8 Well Name and No
SKELLY UNIT #945

SKELLY UNIT #945 DEEPENING PROGRAM

Skelly Unit 945
Chevron USA Inc.
30-015-32964
June 17, 2010
Conditions of Approval

Centralizer Diagram

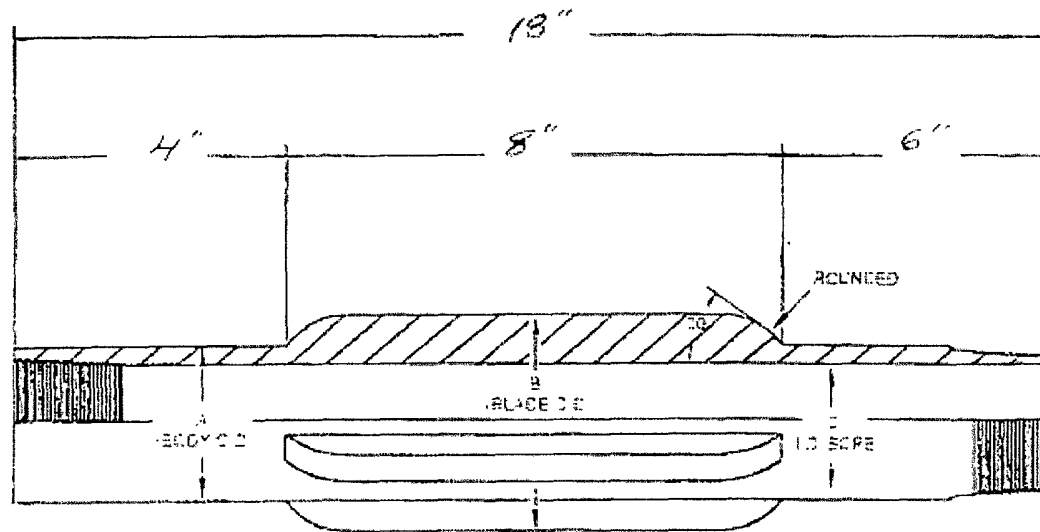
5. BOP to be tested to **1000 psi** based on BHP expected.
6. Variance for stand-off of less than 0.422" is approved due to NMOCD classifying the formations in this area as the Yeso group.
